Our Ref: CRM.1132.021.HY.L.001.B

Application No.: 20/00315/OUT

Hempsted Lane, Gloucester, GL2 5DB - LLFA Response Letter

Figure 1: Google Street View of Highways to the North of the Site

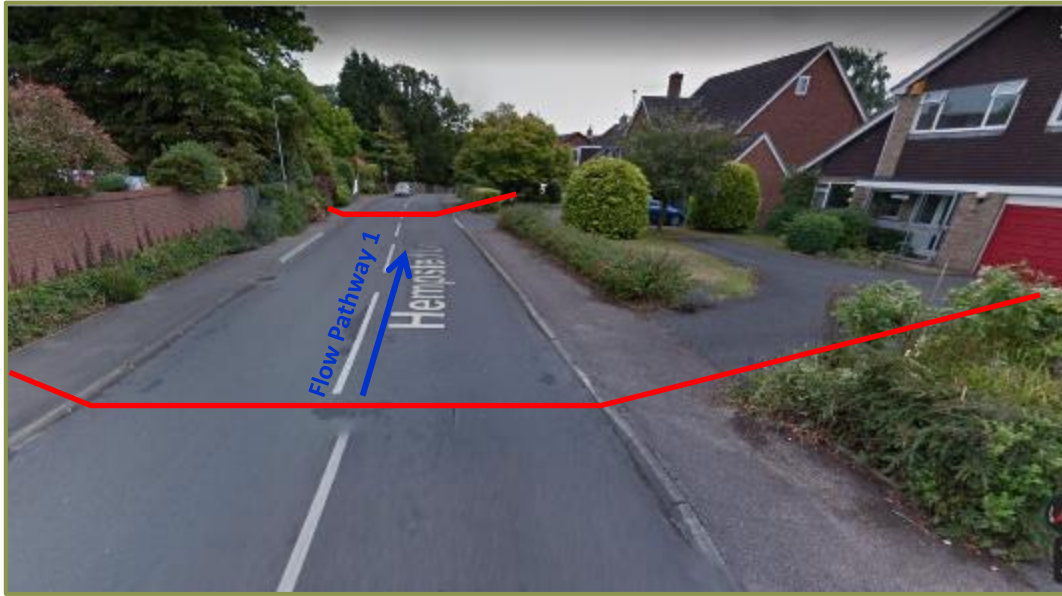
An intercept ditch / swale is required along the top of the development to protect it from overland runoff from the north.

The residential dwellings to the north of the Site are served by a surface water drainage network (see Figure 4 below). Storm events beyond the design standard of the network would shed overland as shallow flows, following the local topography (south) towards the Site.

Hempsted Lane is orientated south-east to the north-east of the Site and is served by highways drainage with road gullies observed along the road adjacent to the Site (Figure 1 - Flow Pathway 1). Note, the residential dwellings (including gardens and driveways) between the northern boundary and Hempsted Lane to the north are topographically higher than the highway. Any overland flows are mostly going to be intercepted and conveyed along the highway (mostly up to 150mm) as per the Environment Agency complex surface water mapping (Figure 2, top).

Rea Lane is orientated south-west to the north-west of the Site and was not observed to be served by highways drainage (Figure 1, bottom). However there is a notable embankment associated with a hedgerow along the Site boundary. Any overland flows are mostly going to be intercepted and conveyed along the highway (mostly up to 150mm) as per the Environment Agency complex surface water mapping (Figure 2 - Flow Pathway 2).

Figure 3: Topographic Survey Extracts

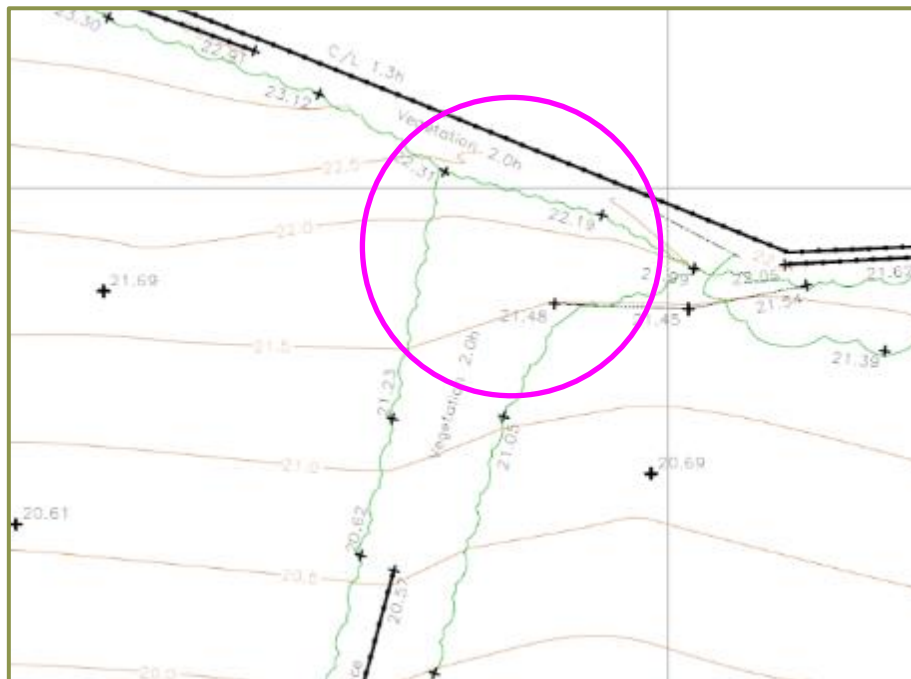
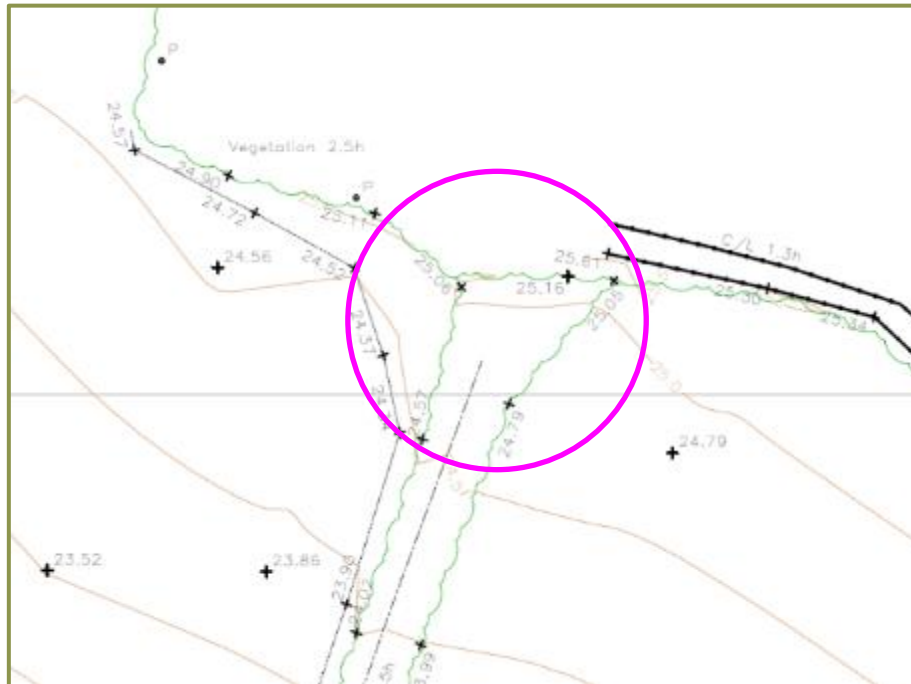
More commitment to SuDS provision is needed.

As per the topographic survey (Figure 3) and Severn Trent Water asset plans (Figure 4), there are no outlets from an upstream drainage network. As such, additional attenuation volume within the basin will not be required.

DRAWING TITLE:
Proposed Drainage

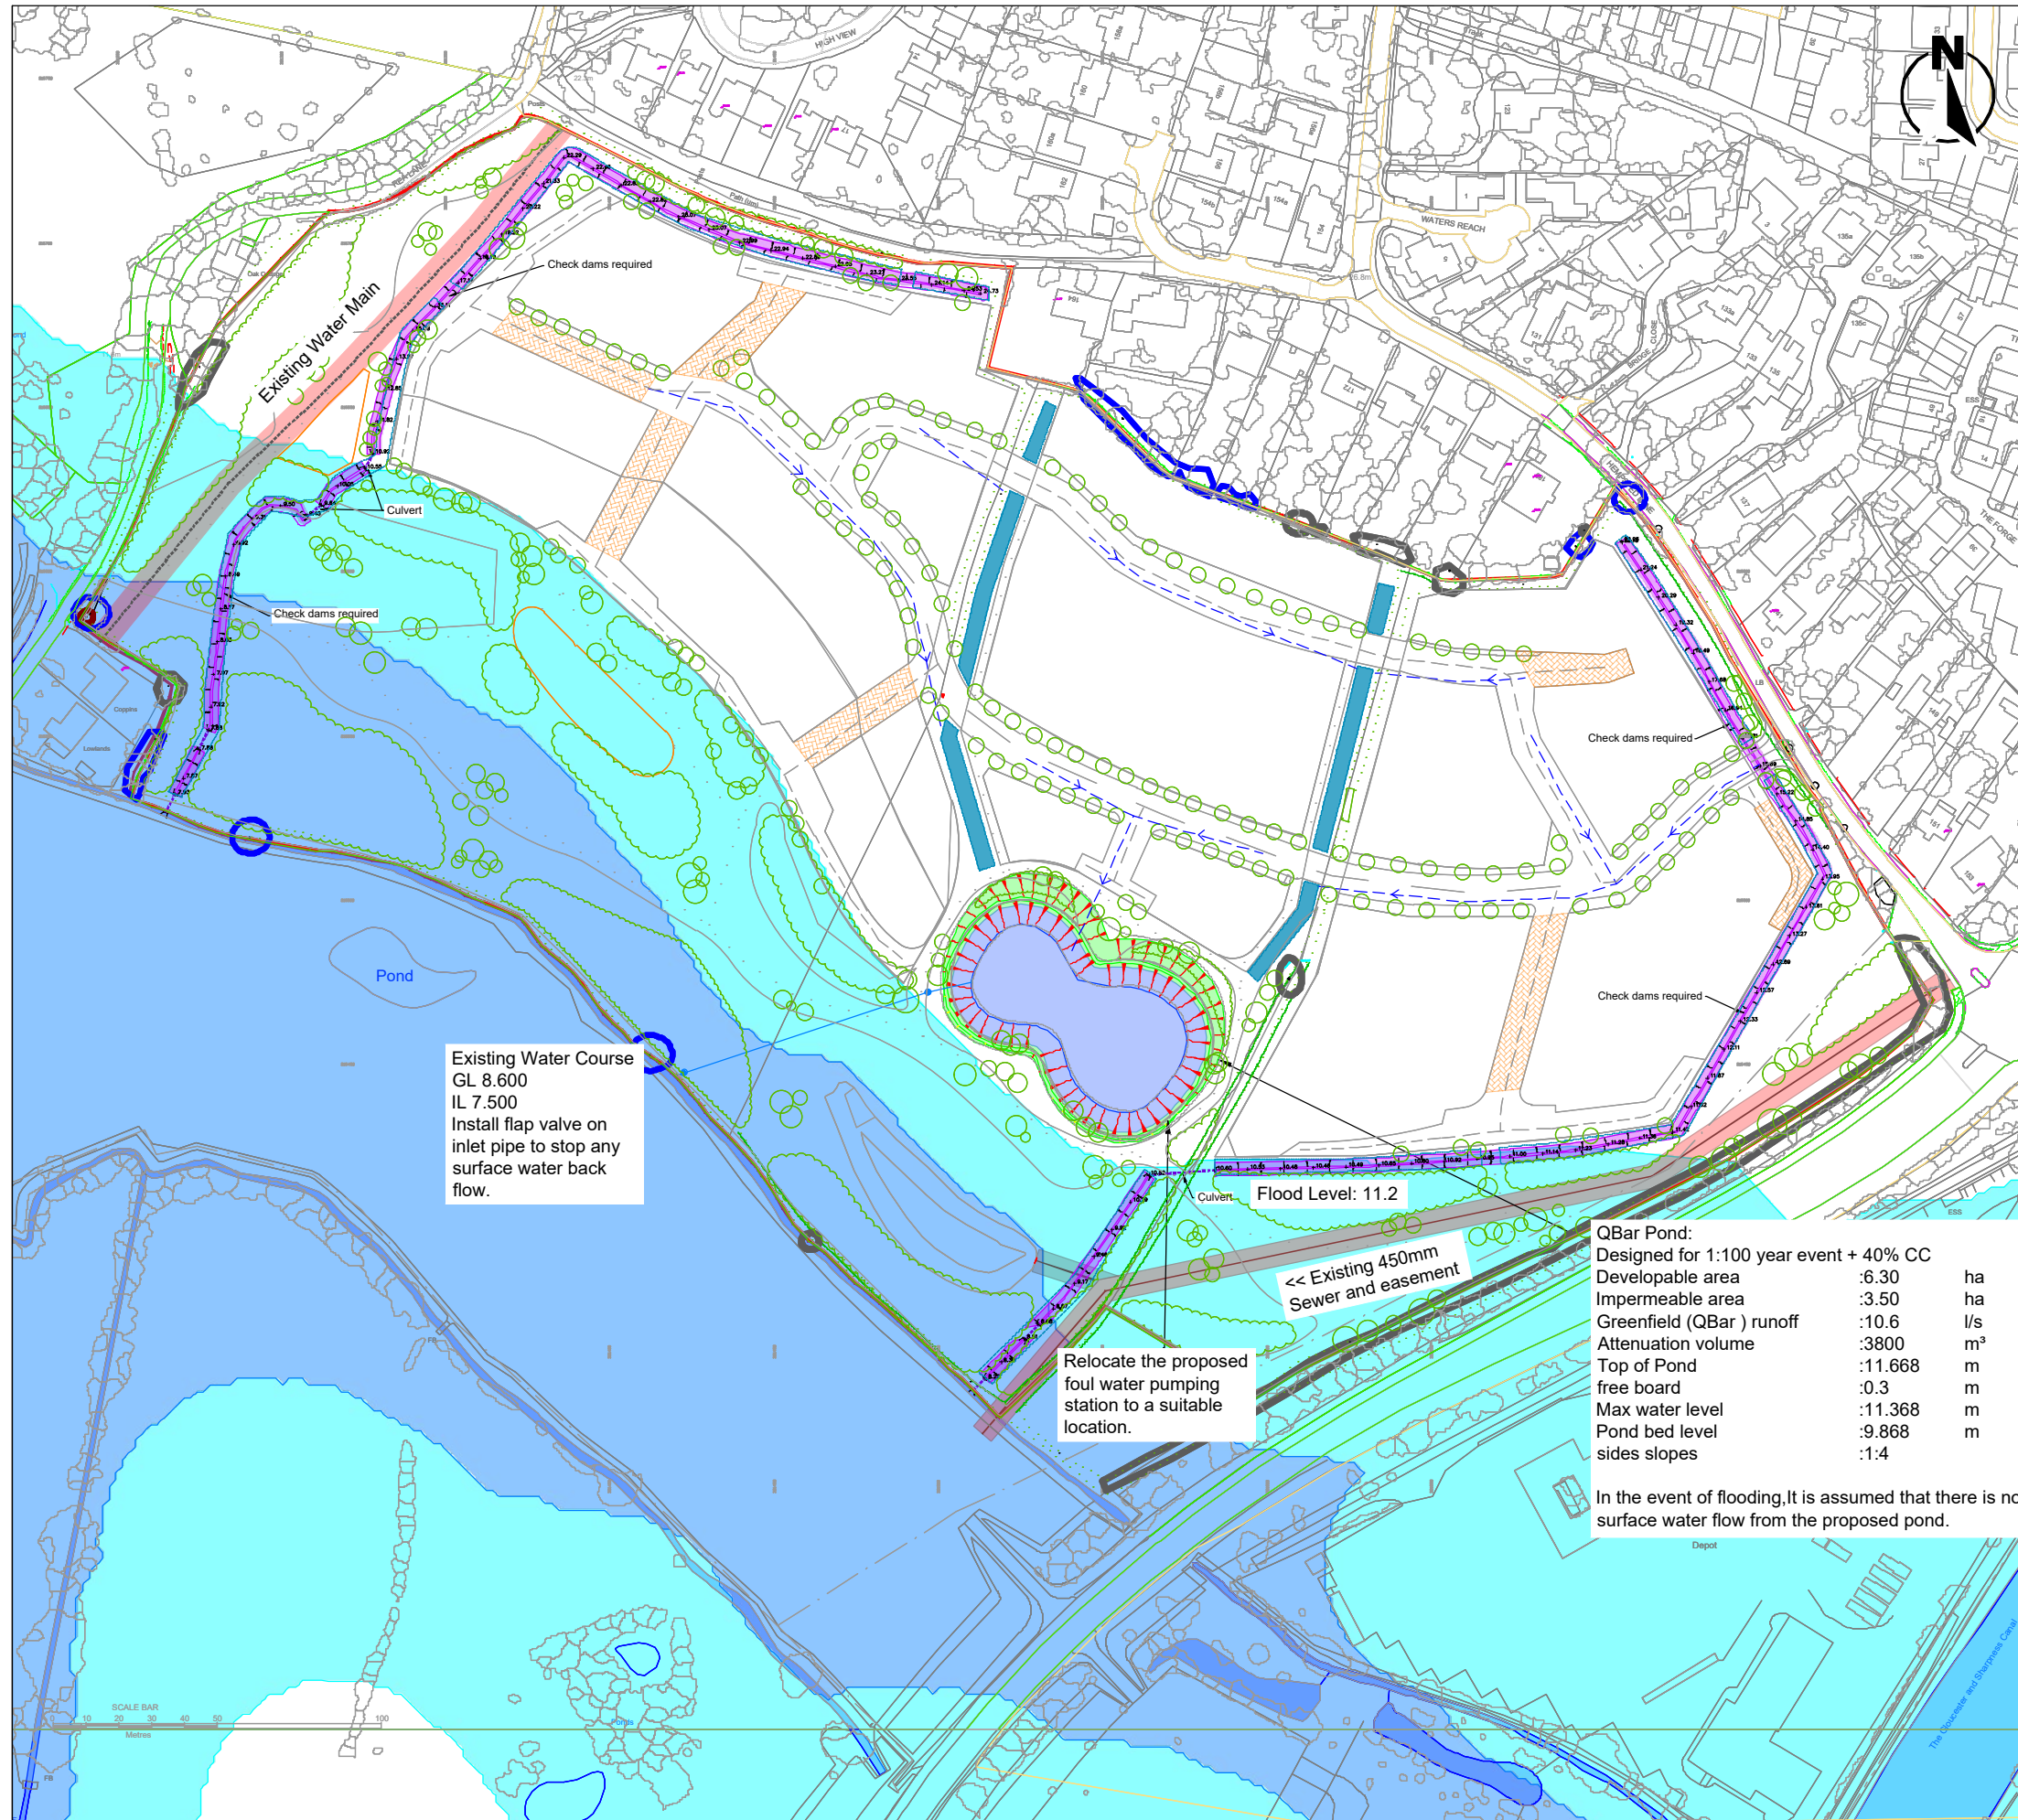
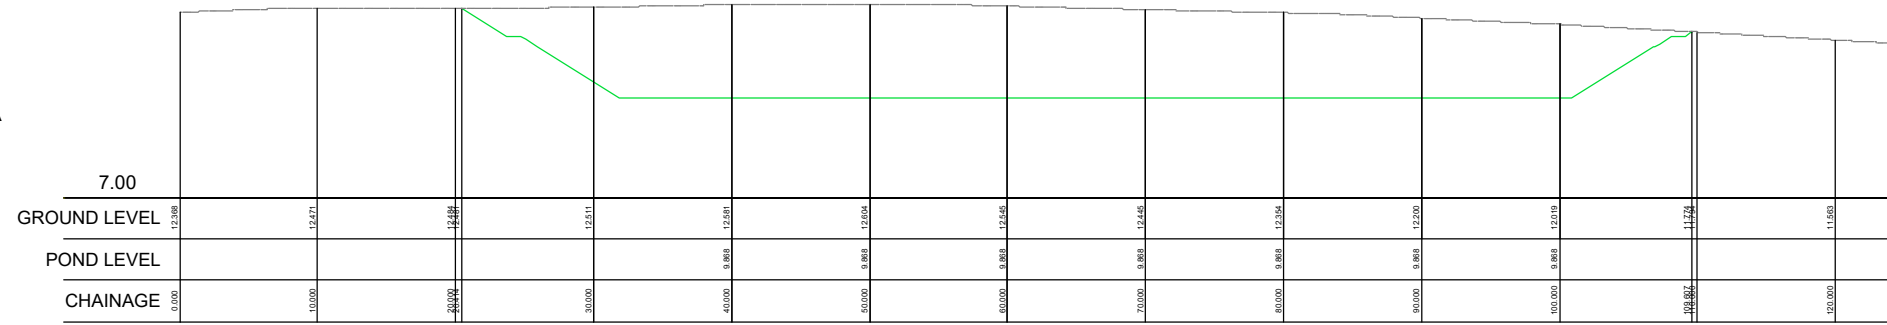
Basin too rectilinear (man-made) looking / the basin may need reconfiguring to produce an acceptable design (no large bund).

The basin has rather man-made rectilinear layout; this should be softened.

I suspect that the layout shown involves a tall bund on the downslope side, although until we see sections it is hard to tell. As set out above, perched basins and large bunds are to be avoided. They look unnatural and also pose a risk in the sense of presenting a potential breach (bank failure) opportunity.

A more linear basin, working with contours, would sit better.

Revised drainage drawings are included in Attachment 2. Swales are positioned along the north-west and north-east boundary, which then conveys flows through the western and eastern extents of the Site (respectively), with outfalls to Hempsted Brook to the south. Any runoff entering the Site from the identified flow pathways along the adjacent highways would be intercepted by the swales.

Revised drainage drawings are included in Attachment 2, which shows surface water drainage runs being directed to two swales orientated north to south, along the reaches of Drain 1 and 2. The swales will direct flows to the proposed detention basin, which will provide additional stages of treatment before discharging to Hempsted Brook. Check dams will be required along the length of the swales to reduce the velocity of flows and prevent erosion.

Revised drainage drawings are included in Attachment 2, which includes a revised basin profile.

DRAWING TITLE:
Proposed Basin Sections

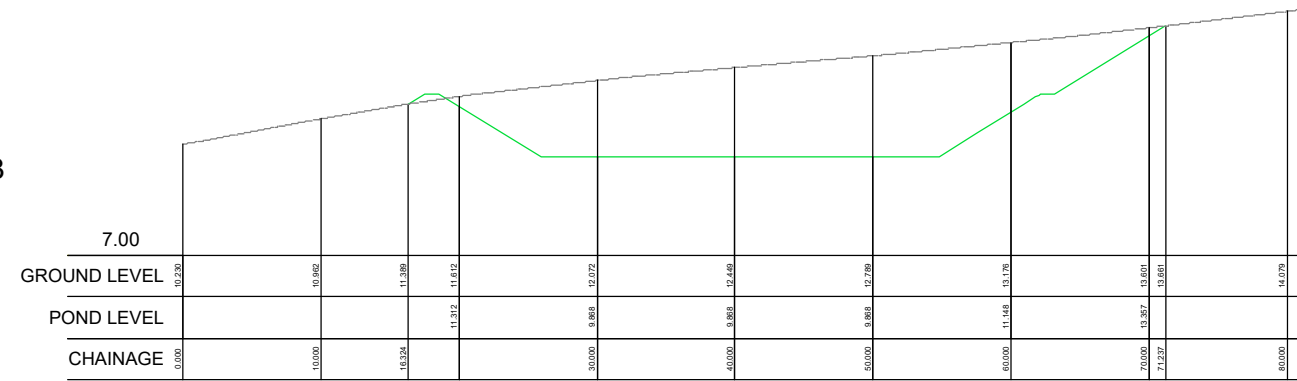
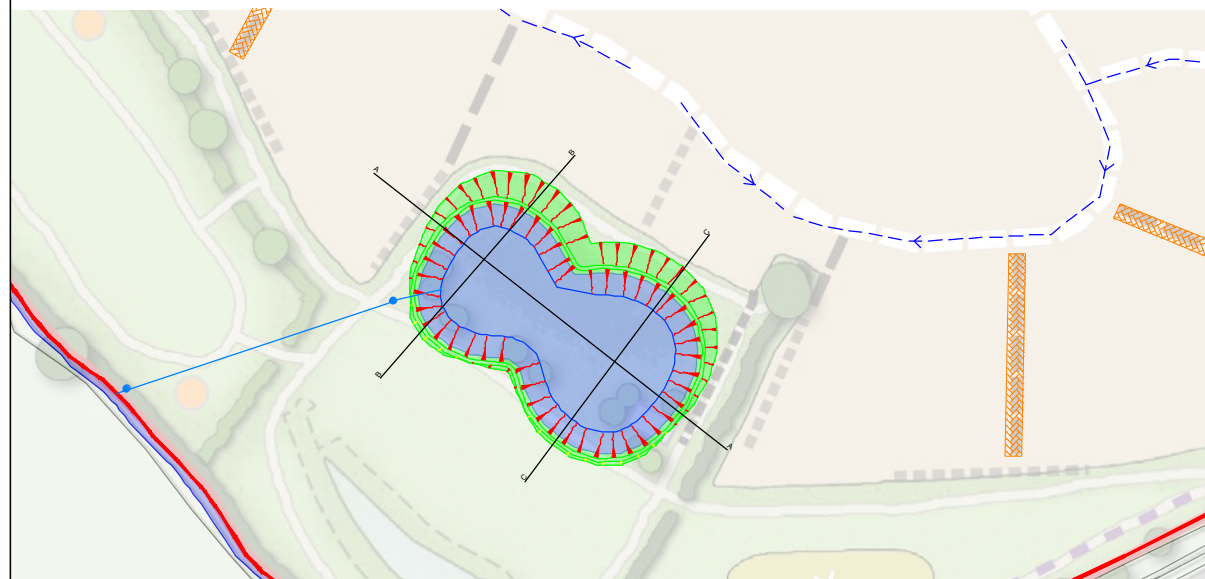
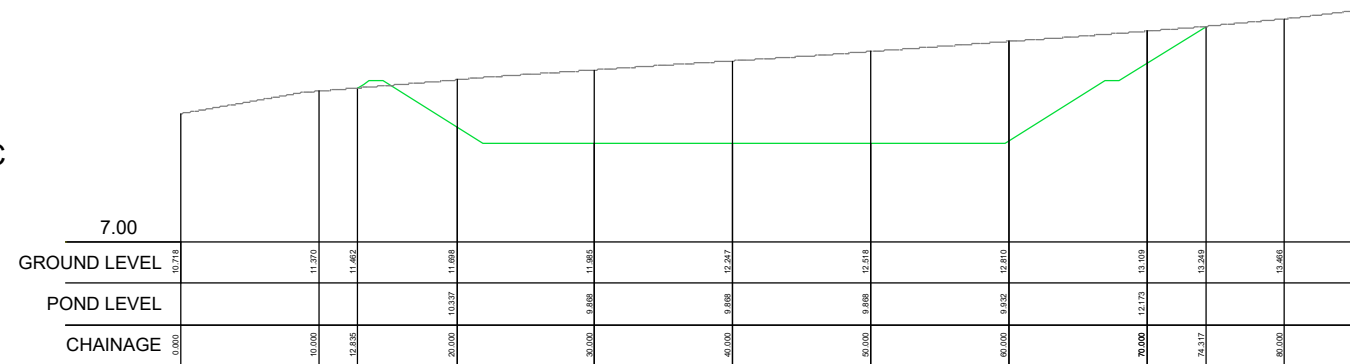
Sections through the basin are required so we can see if it can be accommodated, in an acceptable manner, into the space allocated.

Whilst we do not need to see the full detailed design of the basin as part of outline planning application it needs to be demonstrated that the attenuation volume required can be comfortably, and safely, accommodated within the space allocated. With this in mind, an outline planning application should include a few indicative sections. I would like to request that these are submitted.

Revised drainage drawings are included in Attachment 2, which include basin cross sections.
